### ADDENDUM # 3

#### **Bid 19C14, Rock Creek School Replacement Project**

To: All Plan Holders  
Project: Rock Creek School Replacement  
Walkersville, Maryland  
Re: Addendum #3

P302

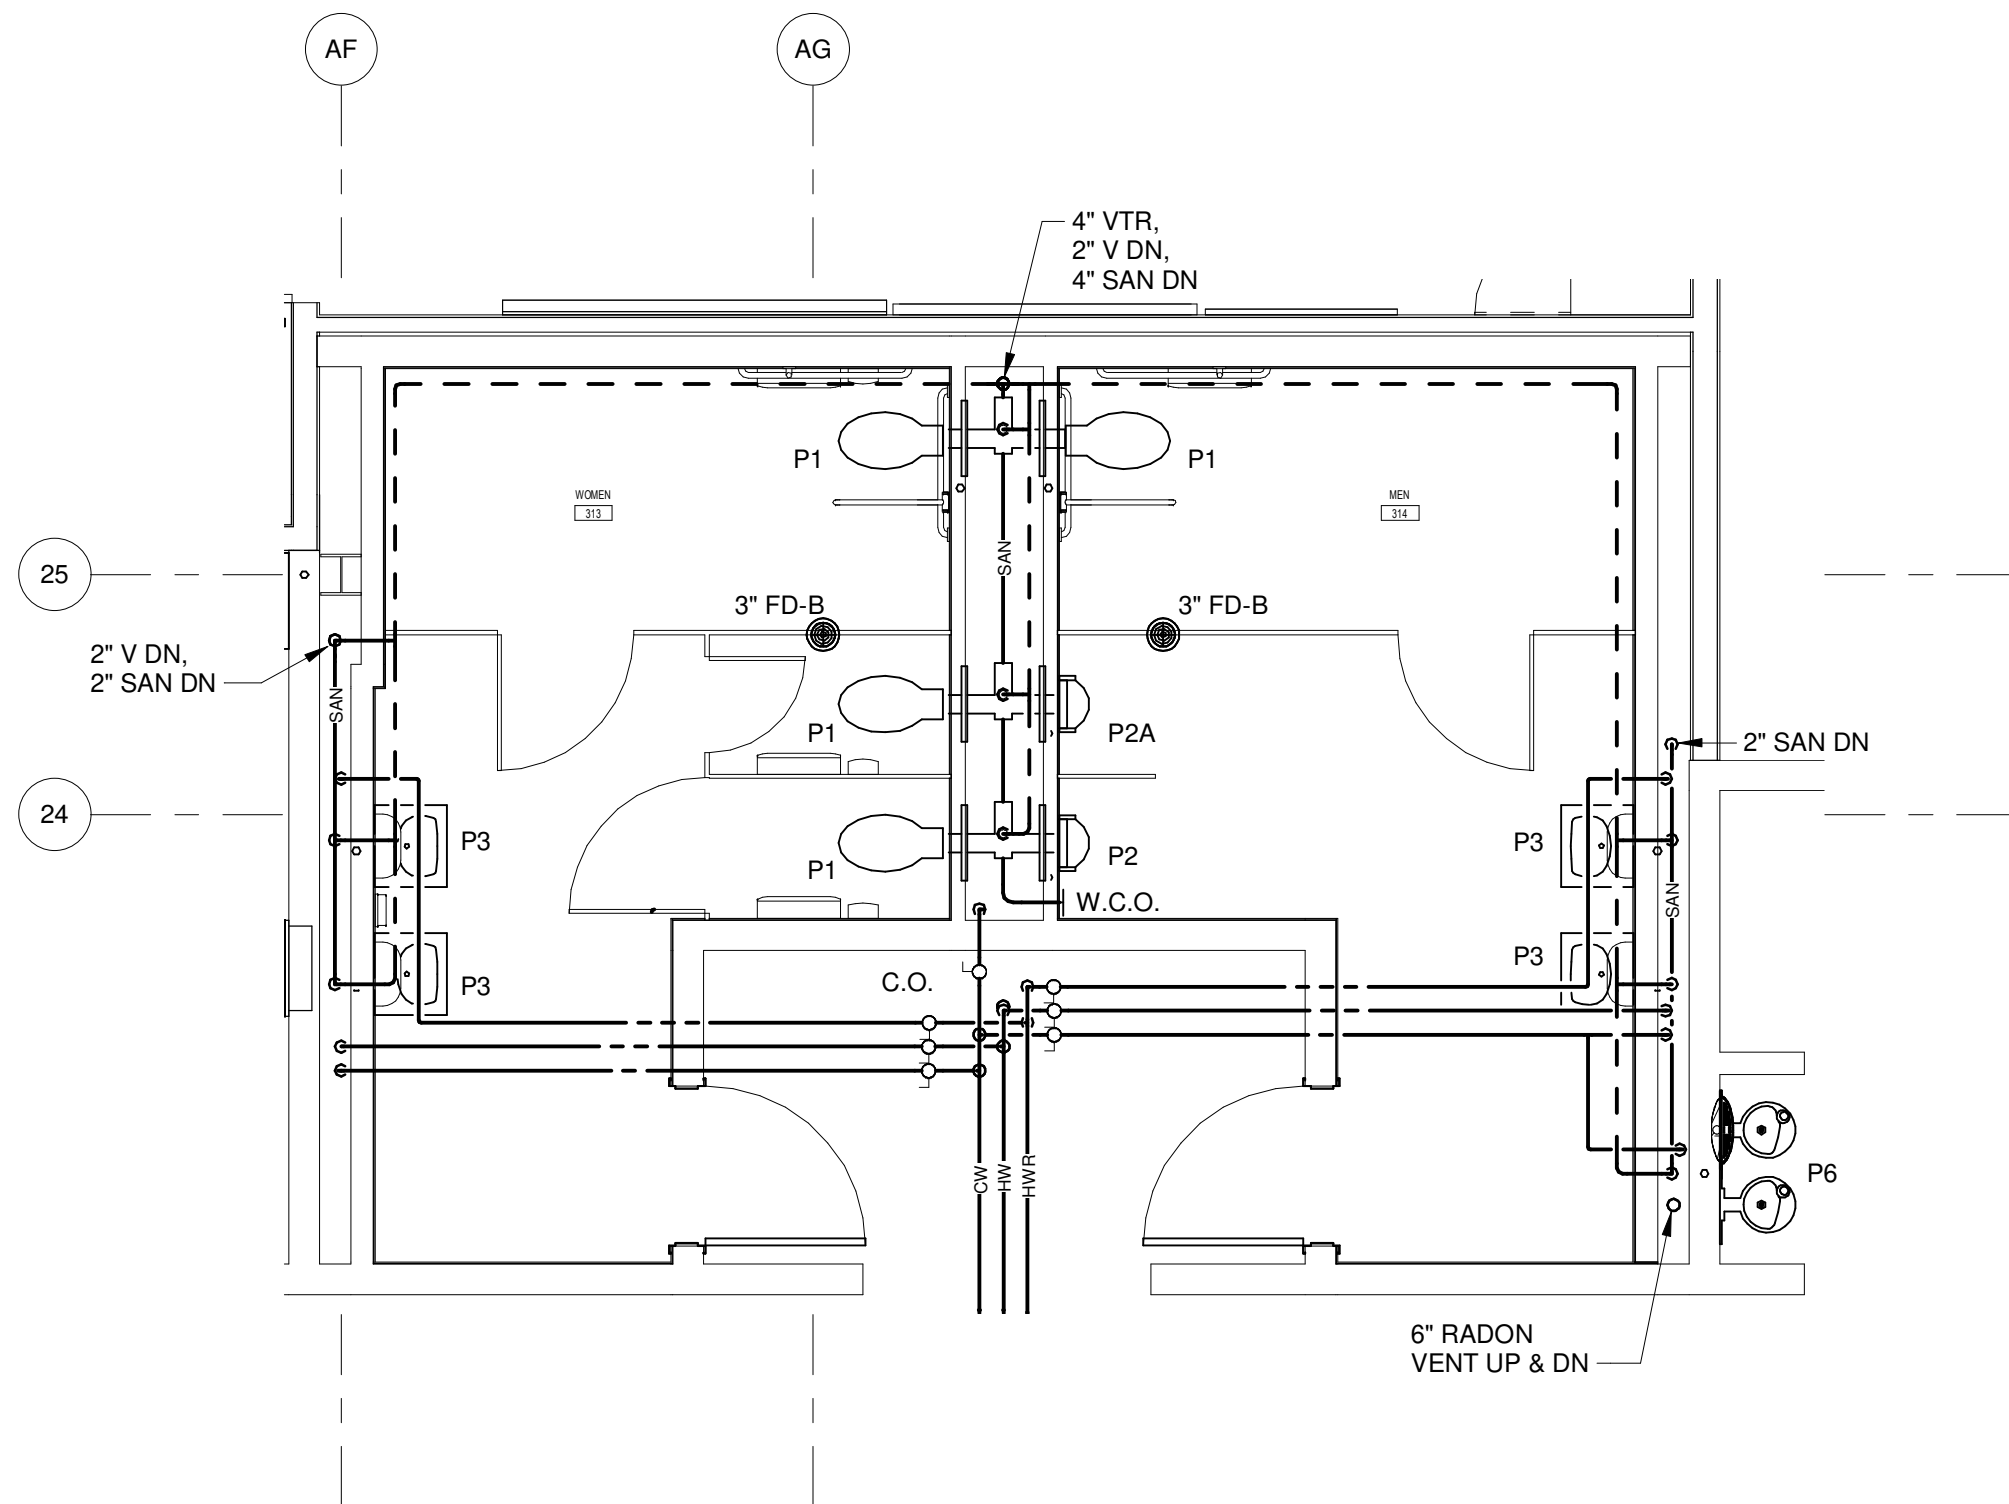
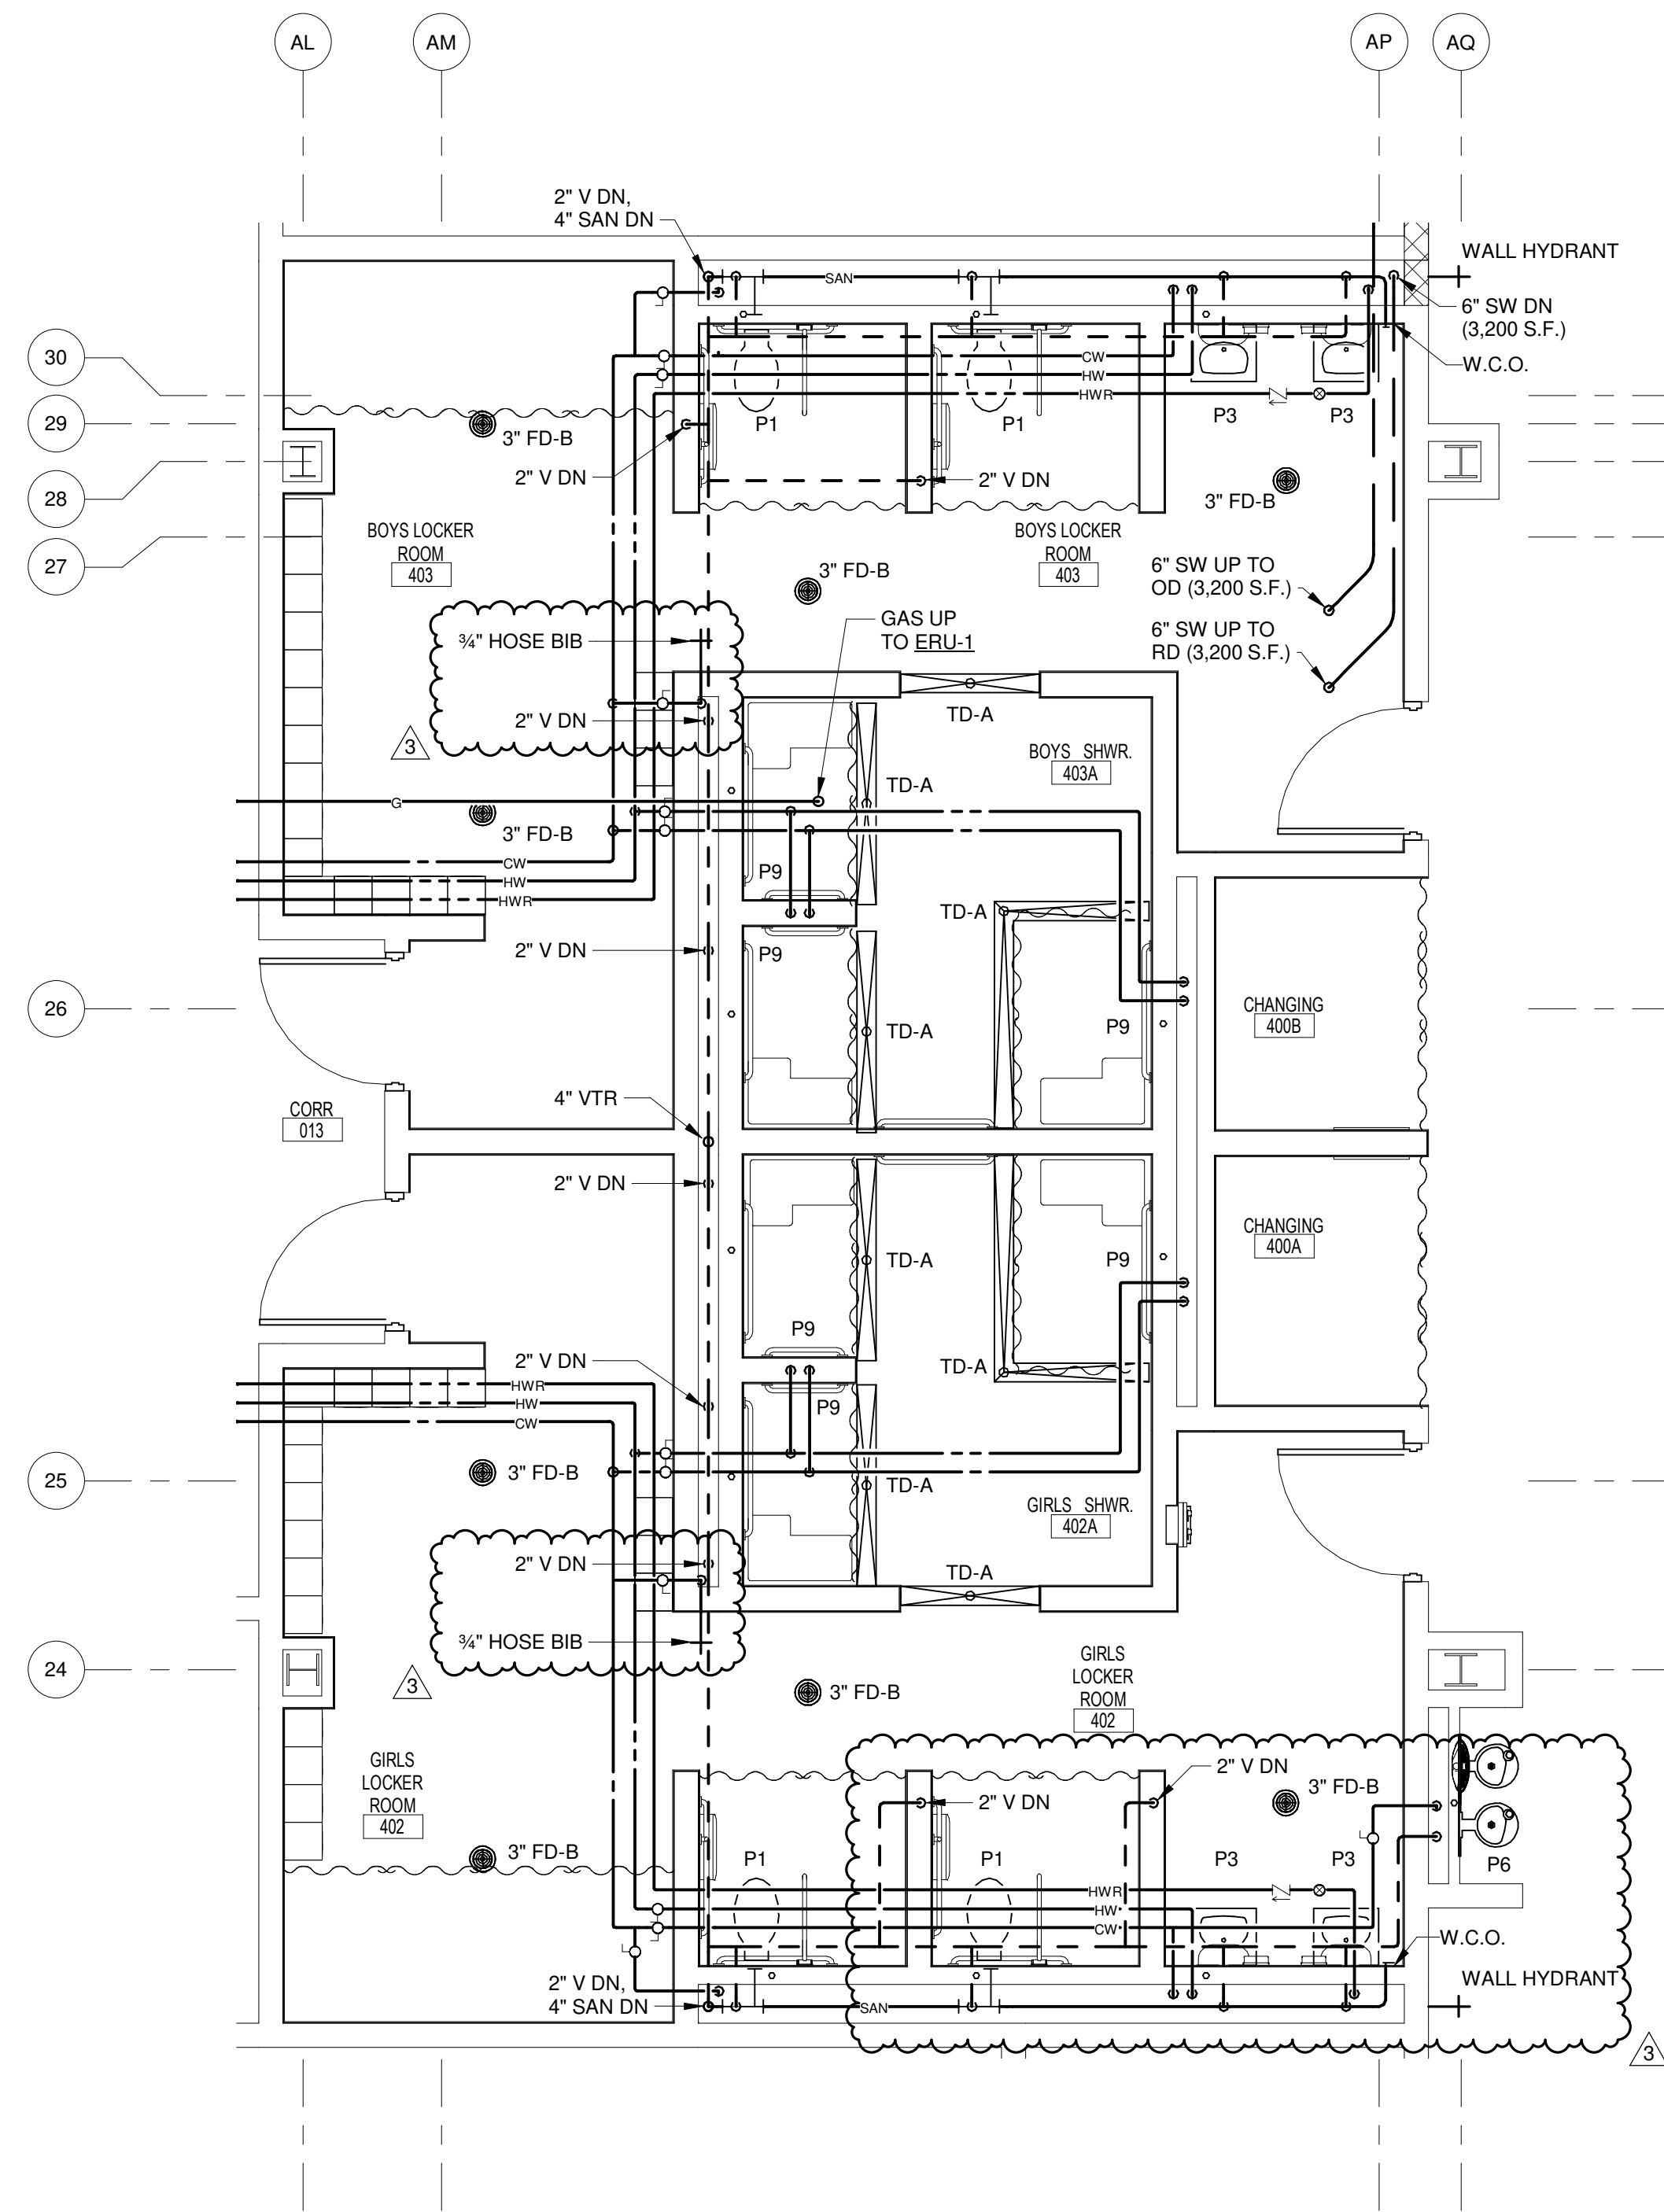
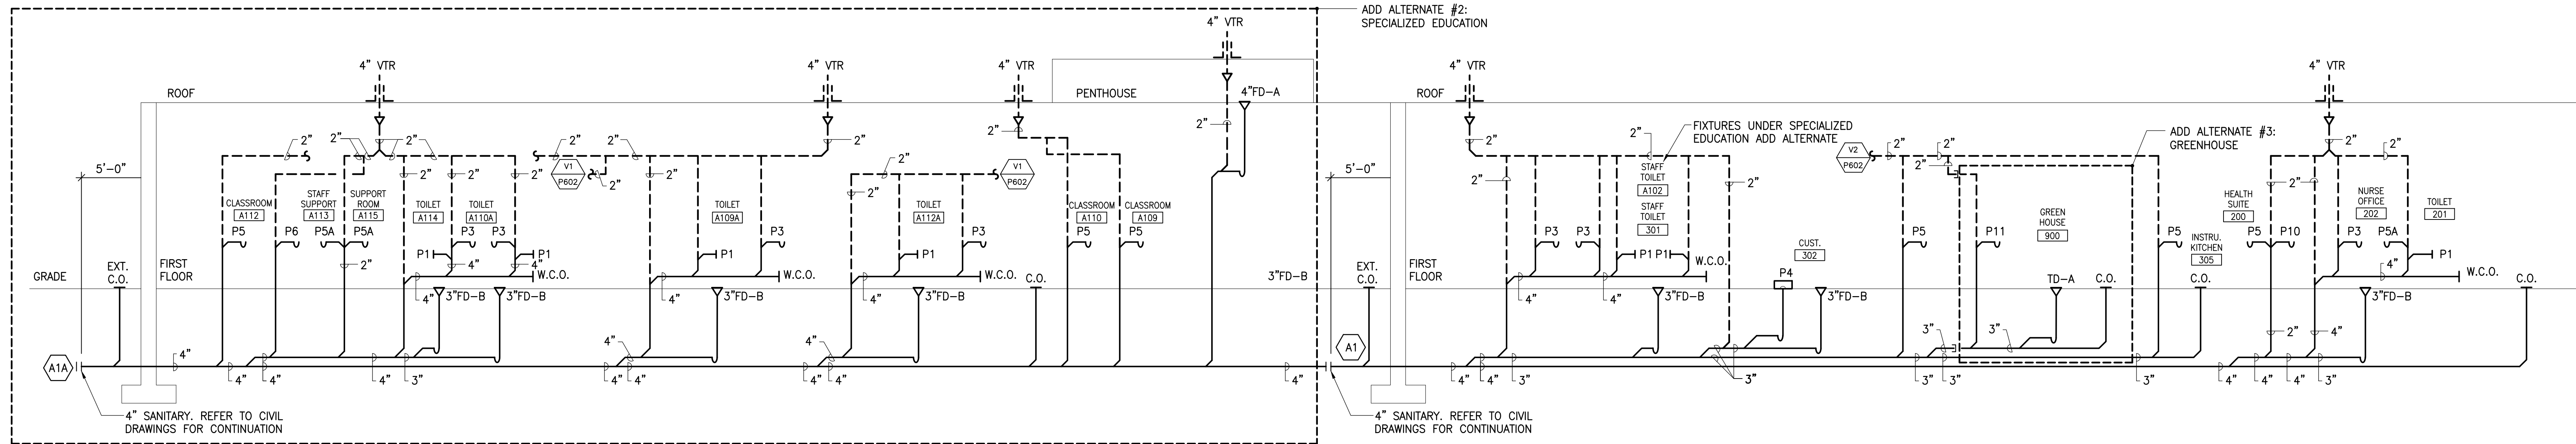
- **REVISE** - Revise sanitary and vent piping layout for drain lines serving Girls Locker Room 402.
2. **P302 – TOILET & LOCKER ROOM PART PLANS**
  - **ADD** - Add fixture P6 on wall adjacent to Girls Locker Room 402 and associated domestic cold water and vent piping.

- **ADD** - Add hose bib on wall adjacent to Girls Shower 402A and associated domestic cold water piping.
  - **ADD** - Add hose bib on wall adjacent to Boys Shower 403A and associated domestic cold water piping.

- **ADD** - Add 2" vent piping down serving drain line for TD-A and 3" FD-B in Girls Locker Room 402.
3. **P601 – DOMESTIC WATER RISER DIAGRAMS**
  - **ADD** - Add hose bibs in boys and girls locker rooms.
